PLANNING APPLICATION PLN-20-0098

847 HOBART ROAD, BREADALBANE

ATTACHMENTS

Description of proposal: Proposed Dwelling

DRAWING
SITE PLAN

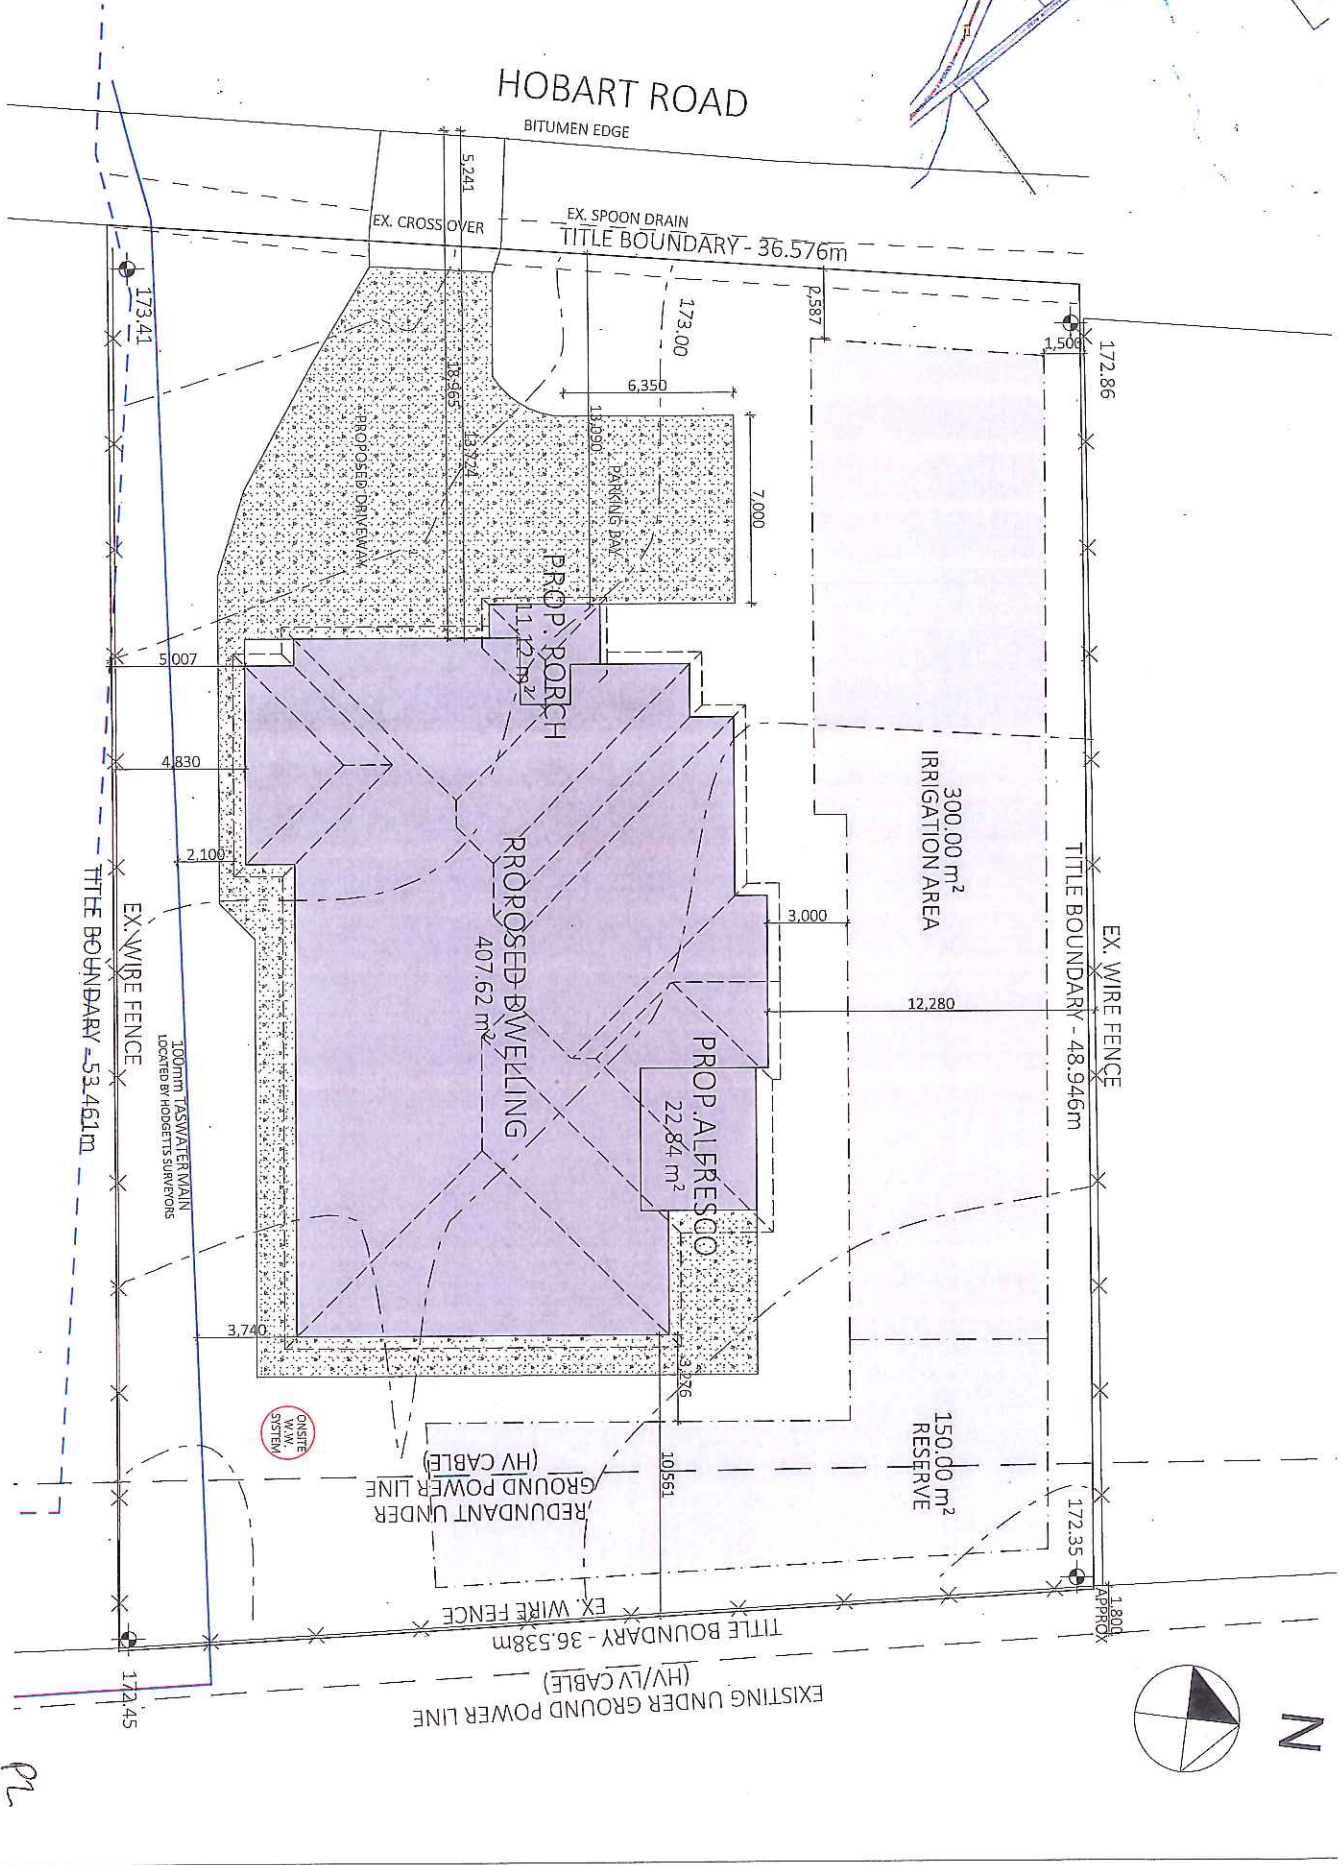
Design to Live drawing 2/7 is showing incorrect title boundary. The newly erected fence separating 847 and 851 Hobart Road was erected at the correct survey points.

During the process of locating the services, we have encountered some issues from the title. The title document initially sent (called title – Vos_000020, attached for your reference) has some errors in the title 'conversion plan' (P.161446, dated 7 APR 2011) compared to the initial survey date from 1950 and the plan of survey (D.35631, dated 20 JUN 1988).

Our surveyor has provided additional information in his attached files (Drawing number 219185 and PDF called SURVEY INFO 847 HOBART ROAD), this reflects the correct information and the site, as well as exact locations of the taswater pipes.

DRAWING SERVICES:
 EXTERNAL SERVICES

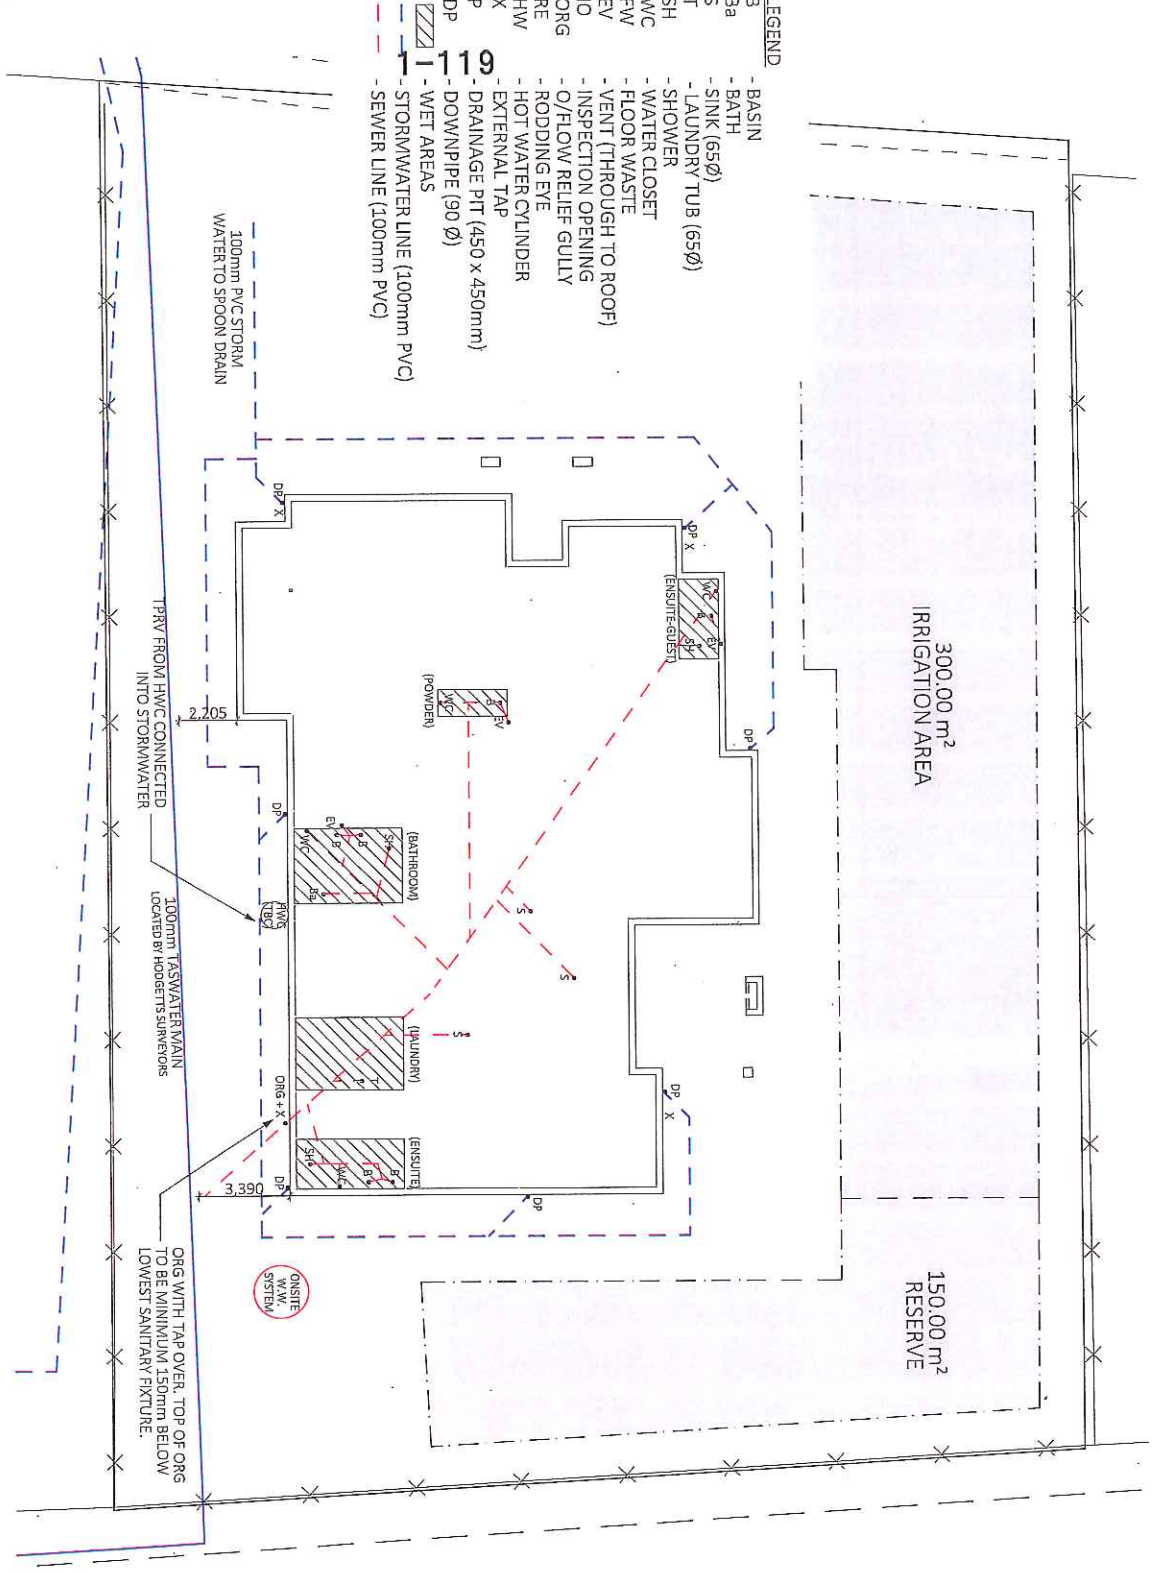
Design to Live drawing 5/7 is showing W.W. system on or very close to Taswater Infrastructure and 100mm PVC Storm water to spoon drain does not allow for run off in existing wrongly placed ditches council enstated in 2014.
